Donald C. Cook Nuclear Plant Units 1 and 2
Nuclear Regulatory Commission Approval of Degraded Voltage Protection Backfit Implementation

Attachment: Functional Description of Degraded Voltage System Backfit Modification

Attachment to AEP:NRC:7321
Functional Description of Degraded Voltage System Backfit Modification

**Sketch - Donald C. Cook Nuclear Plant Unit 1 AC Power Supplies
(Unit 2 power supplies are identical except for component designations.)**

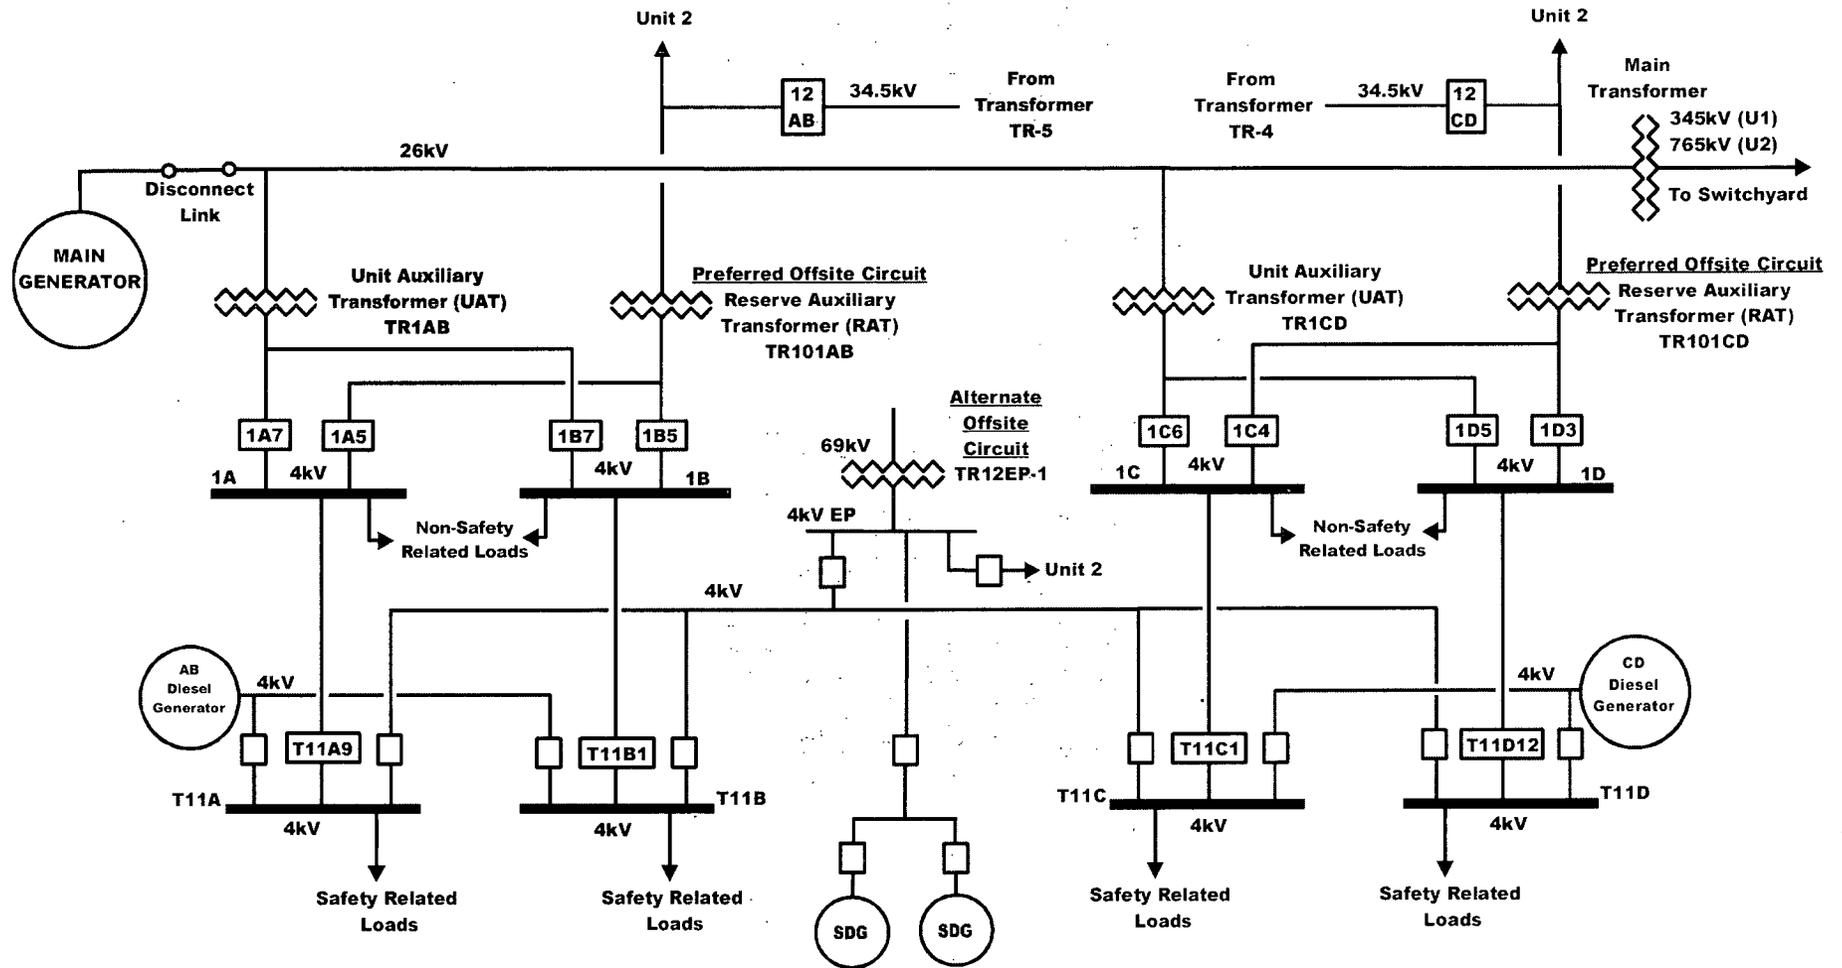
If buses 1A, 1B, 1C, and 1D, and the downstream T buses are being fed via the RATs, a degraded voltage condition that satisfies the applicable time delay will cause the degraded voltage relays to trip the feed breakers to the T buses. These feed breakers are breakers T11A9, T11B1, T11C1, and T11D12 on the attached sketch. The resulting loss of voltage to the safety-related T buses will then initiate a load shed sequence, start the EDGs, and sequence loads onto the T buses in a predetermined order.

If buses 1A, 1B, 1C, and 1D, and the downstream T buses are being fed via the UATs (i.e., the UAT feed breakers 1A7, 1B7, 1C6, and 1D5 on the attached sketch are closed), contacts derived from the open position of the RAT feed breakers 1A5, 1B5, 1C4, and 1D3 block the trip function of the degraded voltage relays thereby preventing the relays from tripping the feed breakers to the T buses. In this configuration, the degraded voltage relays will produce only an alarm in the control room. The relays will not cause the T buses to separate from the UATs in response to bus voltage conditions that meet the setpoint and time delay criteria. Therefore, the automatic degraded voltage protection is bypassed when buses 1A, 1B, 1C, and 1D, and the downstream T buses are fed via the UATs, i.e., during normal Mode 1 power operation. Additionally, the automatic degraded voltage protection is bypassed for 30 seconds following a reactor trip, because the main generator remains connected to the UATs and the transmission network for 30 seconds before tripping, provided there is no signal, such as a generator fault, which would result in a generator trip.

- The RAT feed breaker 1A5, 1B5, 1C4, and 1D3 position function that prevents the degraded voltage relays from tripping breakers T11A9, T11B1, T11C1, and T11D12 will be removed from the breakers' control circuits.
- The degraded voltage protection logic will be modified such that a fast bus transfer from the UATs to the RATs will occur in response to sustained degraded voltage at the monitored

T buses, T11A and T11D, when they are fed from the UATs. The fast bus transfer from the UATs to the RATs will be implemented in a similar manner as the existing fast bus transfer. The bus feed breakers from the UATs and RATs will receive simultaneous trip and close signals respectively, resulting in minimal dead bus time.

- If no accident signal (safety injection or low-low steam generator level) is present and a degraded voltage occurs on the T buses, buses 1A, 1B, 1C, and 1D and the downstream T buses will transfer from the UATs to the RATs after approximately 99 seconds. The degraded voltage condition on the T buses will concurrently initiate the 2 minute time delay. If the degraded voltage on the T buses still exists after the nominal 2 minute delay, breakers T11A9, T11B1, T11C1, and T11D12 will open and initiate transfer to the EDGs.

- If an accident signal (safety injection or low-low steam generator level) is present and a degraded voltage occurs on the T buses, the transfer of the bus 1A, 1B, 1C, and 1D from the UATs to the RATs will be bypassed, resulting in a transfer of the T buses from the UATs directly to the EDGs after the nominal 9 second delay.

- Operators will continue to receive an alarm on a degraded voltage condition regardless of the power supply to the T buses.
